VERMONT YANKEE NUCLEAR POWER CORPORATION

July 10, 1992
BVY-92-082

Subject: Response to Request for Additional Information and Resubmittal of Request to Dispose of Slightly Contaminated Soil in Accordance with 10CFR20.302(a)

RESPONSE TO NRC REQUEST FOR FURTHER INFORMATION ON VY CHEM SINK

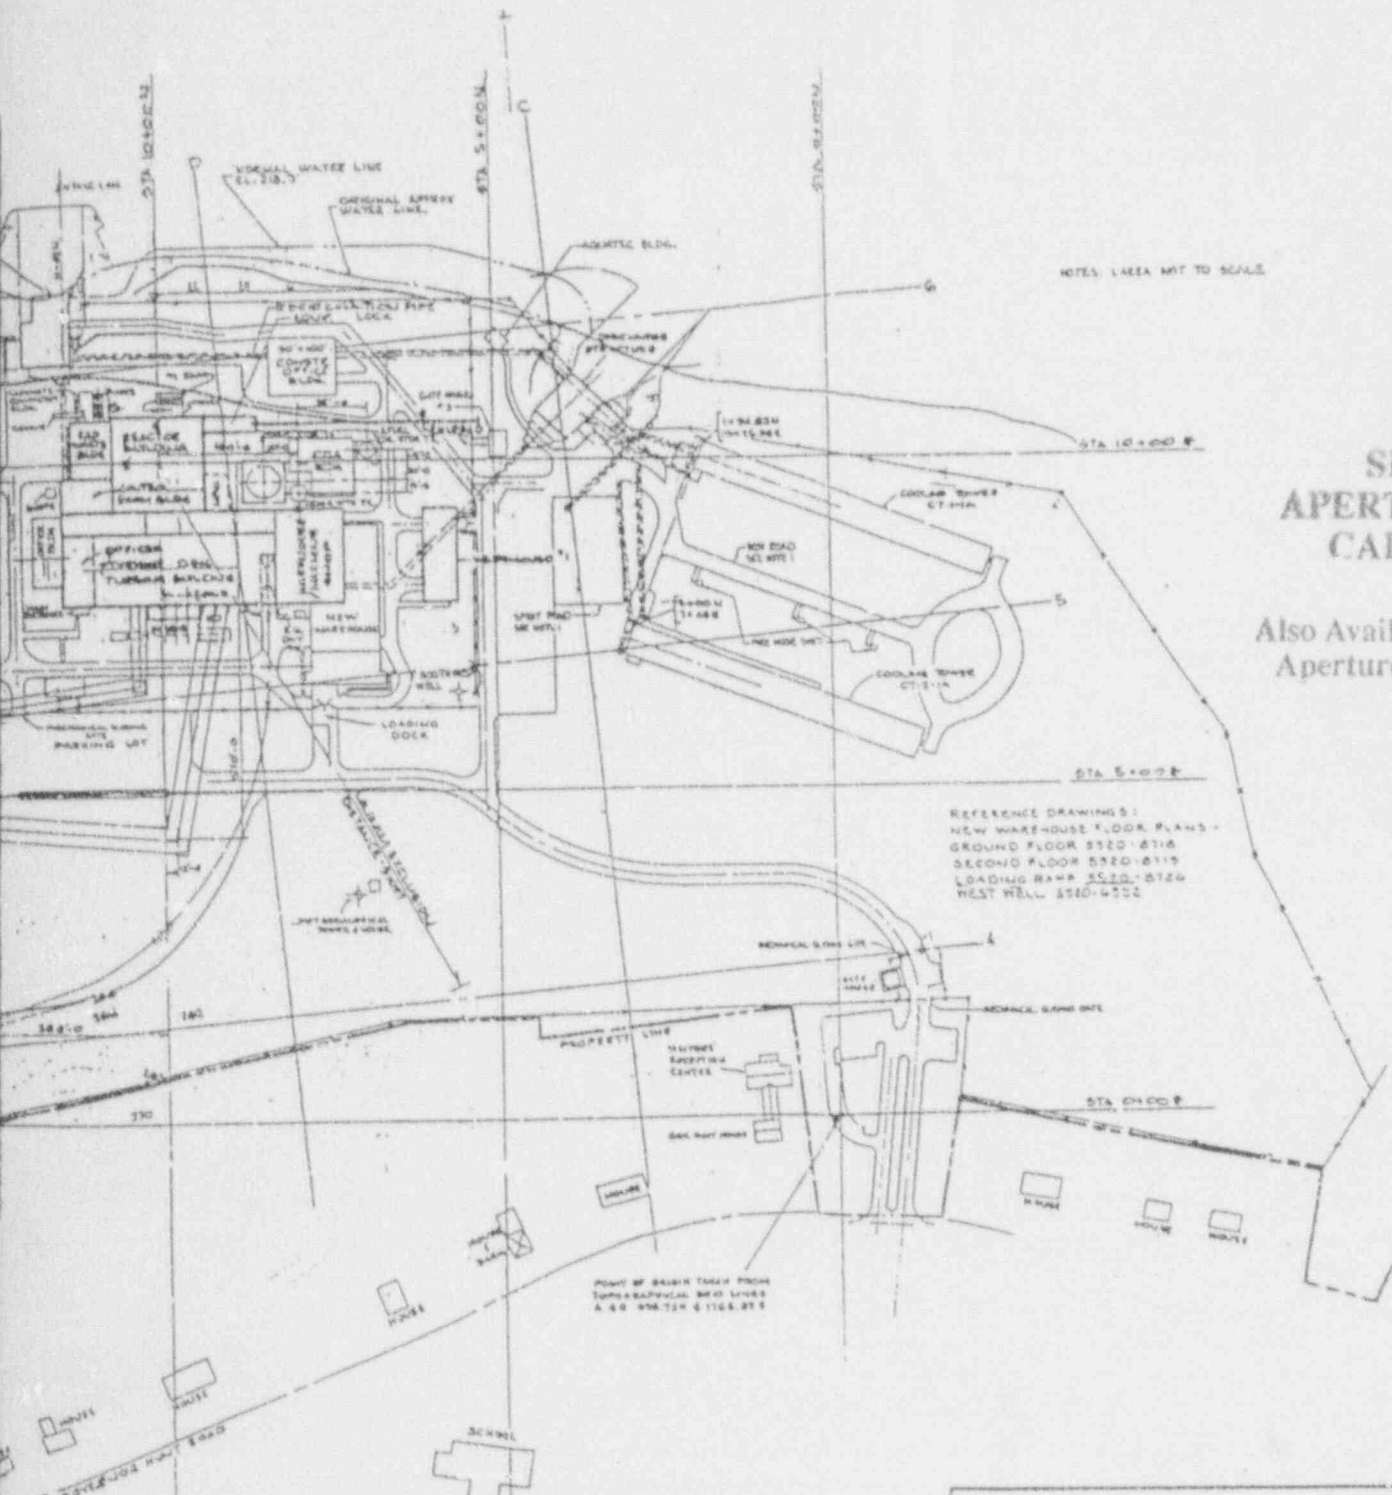
5. The graph titled "BORING MW-1" presents a misleading representation of the distribution on contamination. The x-axis plots the sample depth in a linear manner, which it is not. Additionally, as discussed in question 3, the large gap of missing data between the highest concentration sample and the next sample skews the data representation. Provide a revised graph (including data from question 3) that appropriately reflects actual scale.

ANSWER: The spacing of samples taken for analysis in boring MW-1 was as consistent as sample recovery allowed. Correct sample depths are shown on the graph titled "Boring "MW-1"". Some of the depths of samples presented in Table 1 are off by 1 ft; a corrected copy of this table is attached. This discrepancy resulted from the use of both the top and the bottom of the lab floor as a datum for sampling during the course of the boring operation, and the fact that these reference points were established as exactly 1 ft apart. This difference was recognized and corrected as part of the original analysis of the data, however, the original values were mistakenly included in Table 1. The graph has been re-plotted using "inches" rather than "feet and fractions" as the abscissa.
